SITE
SEPARATION

VARIANCE REQUEST

Iowa Department of Natural Resources

**Re: Jefferson, Iowa
Wastewater Treatment Improvements
Request for Variances
FOX P.N. 2486-01A.400**

NEW LAYOUT

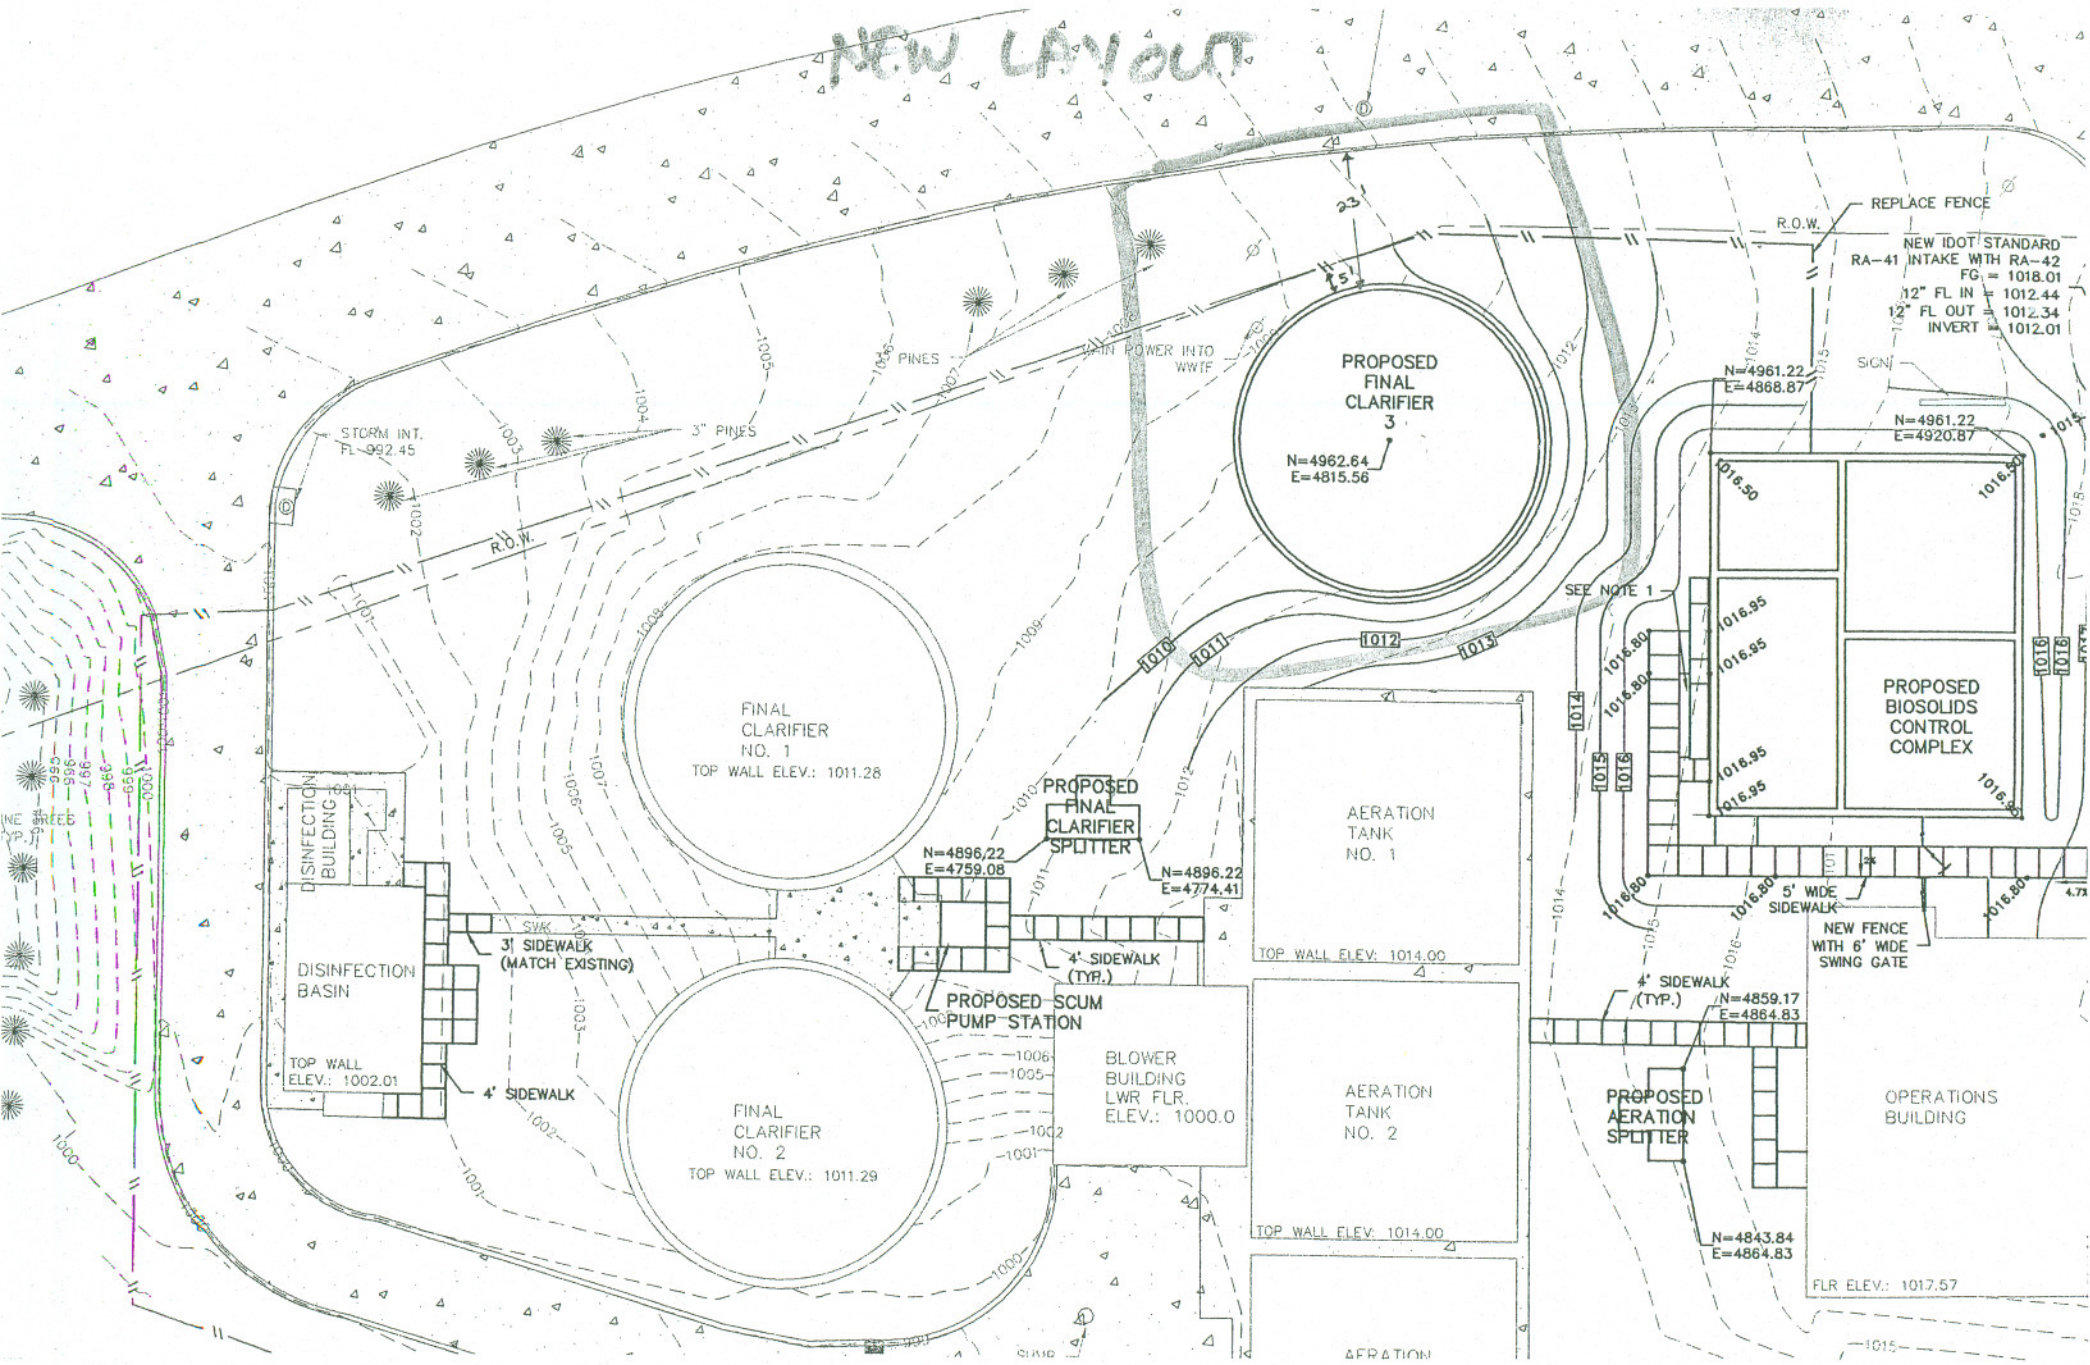
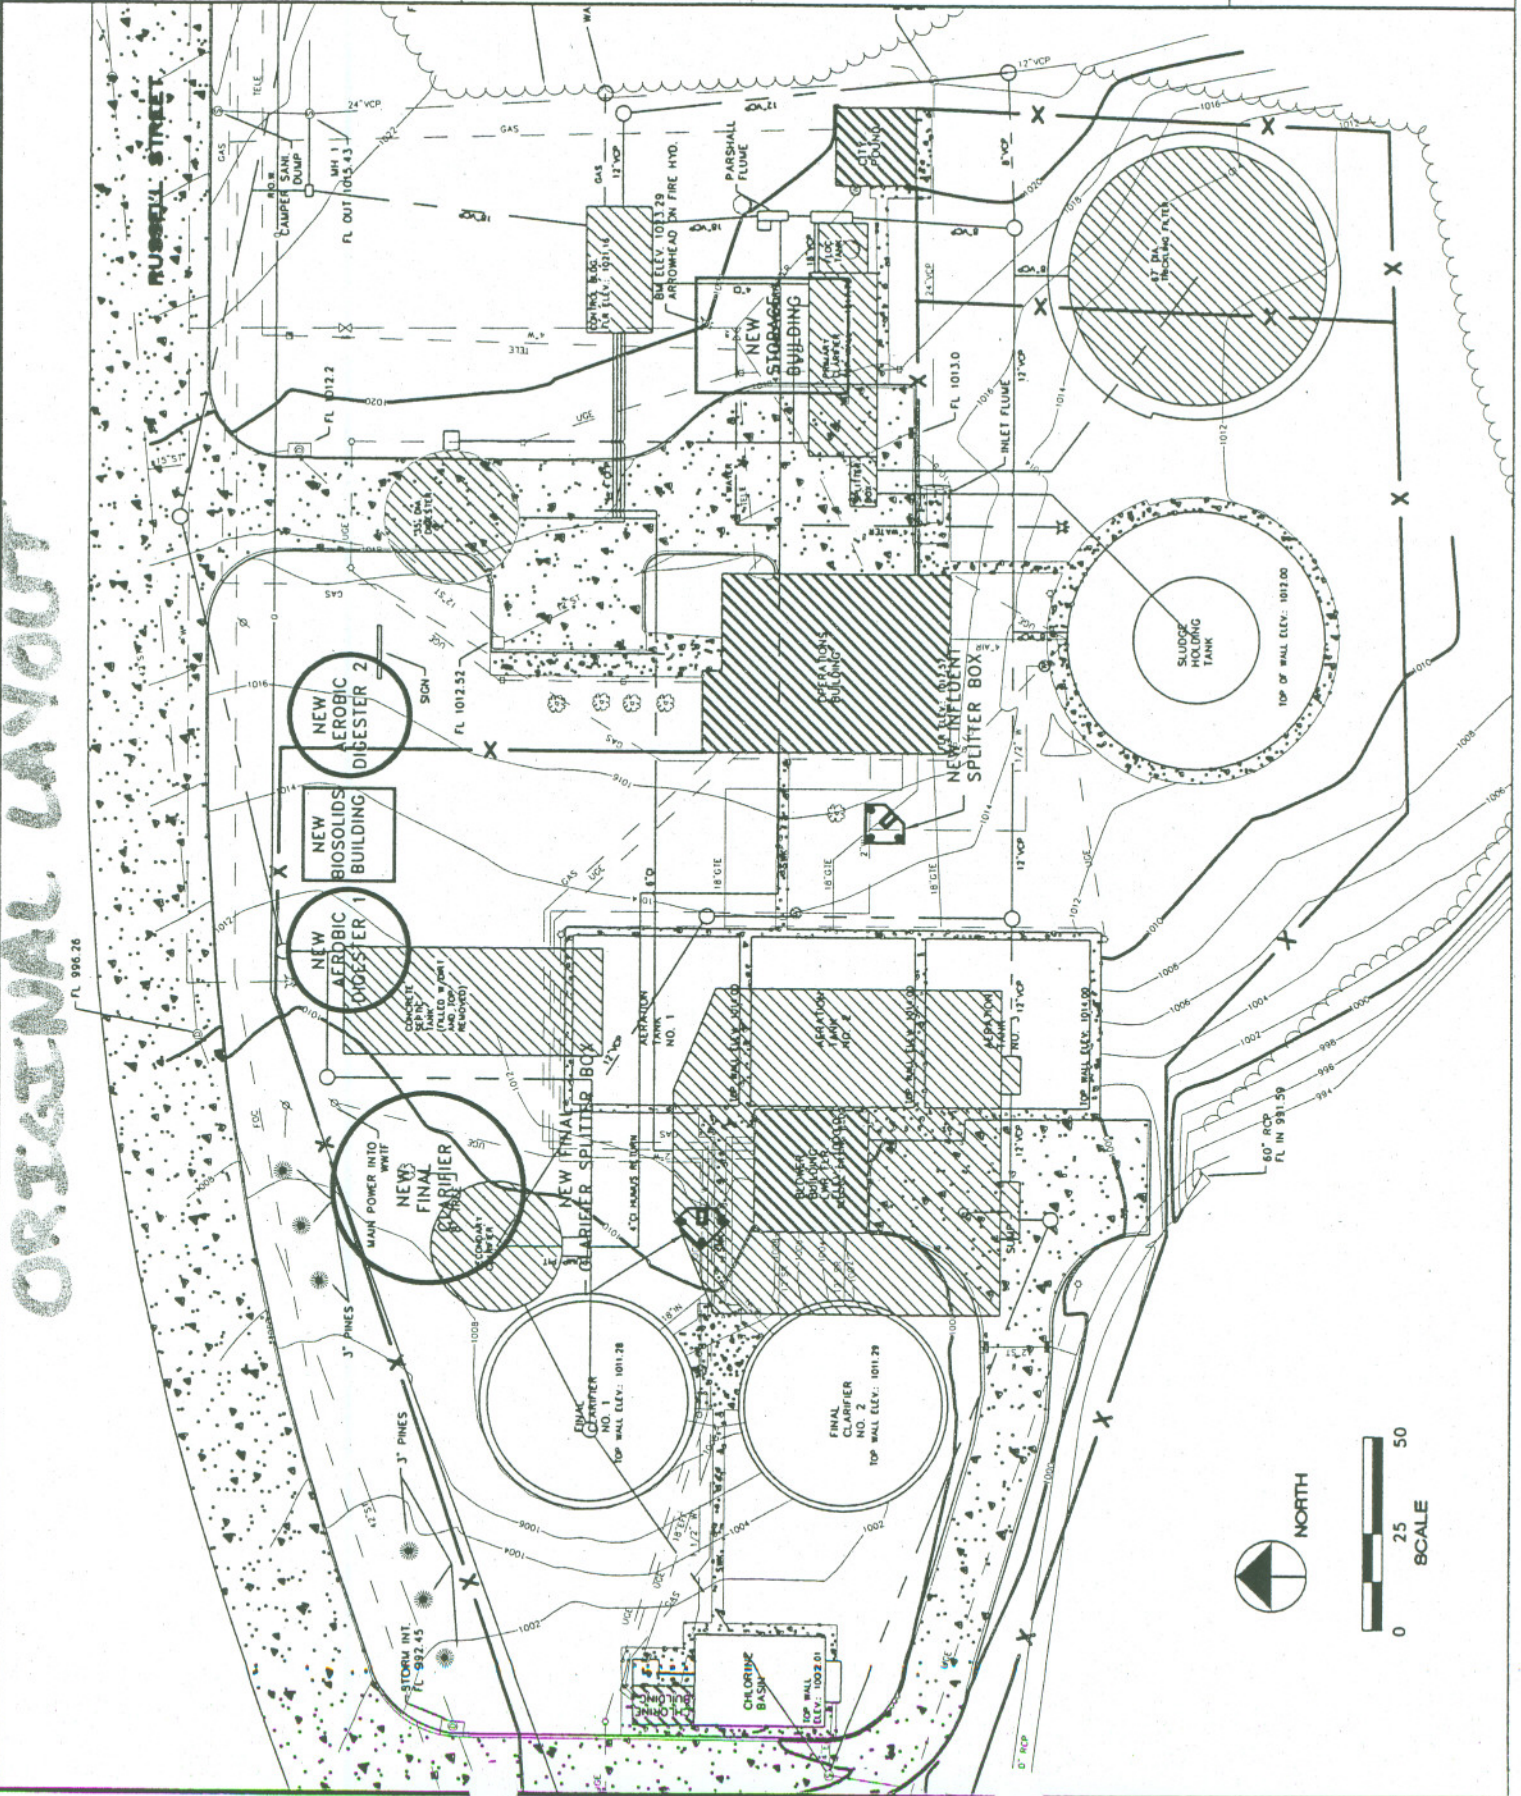
← WENT TO RECTANGULAR DESIGN &
COMMON WALL CONSTRUCTION. R.O.W.
SEPARATION FOR DIGESTER IS
NO LONGER A CONCERN.

← NO LONGER APPLICABLE. SEE
OLD LAYOUT VS. NEW

- Is this a city or county right of way?
- Does the city/county have setback requirements that will be violated and if so, has the siting arrangement been cleared with them?
- Will the storm sewer and fiber optic cable (or any other utilities) be disturbed or need to be relocated for construction?
- Are there any traffic safety concerns?
- It is apparent from the site map that the final clarifier has pretty much no where else to go and the R.O.W. here is wider. Why can't the biosolids complex be pushed back further from the R.O.W.?
- Is fencing to be provided around the new units? Type?
- Have any problems been encountered due to the existing clarifier (and possibly the previously demolished septic tank) proximity to the R.O.W.?
- Are there potential future maintenance issues - i.e. how will the operator access the sides of the units closest to the R.O.W.?

← NOTE: BIOSOLIDS COMPLEX WAS
PLACED FURTHER BACK (PRIMARILY
DUE TO RECT. RATHER THAN
CIRCULAR DESIGN) AFTER THIS

- This is a City Street and Right-of-Way
- The City does have setback requirements for construction, however the City Council has the authority to waive those and would do so for a municipal project of this nature.

- It is possible that the construction activities may disturb utilities in the ROW, but this will depend upon the means and methods utilized by the Contractor. If the Contractor elects to use a construction method that does disturb them, it will be his responsibility to protect or replace them.

- We will include a traffic safety section in the specifications requiring the Contractor to use appropriate signage etc. as required.
- The reason we cannot move the sludge tanks further south away from the ROW is that could cause problems with the control building during the construction phase. The tanks will require significant excavation and we do not want to undercut the building foundation.

- The area will be re-enclosed with chain-link fencing as part of the project.
- I'm not sure what type of problems you may be referring to regarding the units' proximity to the ROW, but we are not aware of any previous problems. All of the tanks in question will be covered, so kids throwing rocks into the tanks from the street should not be an issue.

- The operator will have full perimeter access to the clarifier within the site boundaries. While a final decision has not yet been made on the sludge tanks, we believe that the perimeter fence will tie into the ends of the outer walls so that the walls create a portion of the fence and the operator will be able to access the walls from outside the fence.

IDNR design standards require a separation distance of 25 feet from all wastewater treatment water surfaces to right-of-way property lines. Due to the site limitations, it will be necessary to locate the new clarifier approximately 5-10 feet from the Russell Street right-of-way line. It is anticipated that the IDNR will grant a variance for the reduced separation distance, given that this is the only practical location of the new clarifier. In addition, the existing north clarifier infringes upon the 25' site distance, as it is located only about 15' from the right-of-way line.

1. I agree with the assessment that there is no other practical location available for the new clarifier. Space is available at the northeast and southeast corners of the existing site. However, the two existing final clarifiers are located on the west side of the site and flow to the plant is by gravity. Locating the new clarifier a significant distance from the existing units would increase the operational complexity of the plant and may not be hydraulically feasible. Also, the southeast corner is in the mapped flood hazard area and placement of the new clarifier on the east side of the site will require many more site separation waivers from residences. Space is also available to the west, but it is at a significantly lower elevation and within the mapped flood hazard area.

2. The street is on the edge of town and becomes a gravel road just west of the plant site. The street is not subject to large traffic volumes. The street right-of-way widens at the proposed clarifier location due to the curve in the road. As stated by the engineer, traffic safety provisions during construction are included in the project specifications and any disturbed utilities will be relocated or replaced.

3. The area will be fenced and the new clarifier will be covered. No increase in nuisance odors will result from the reduced separation distance and access to the unit will be restricted.
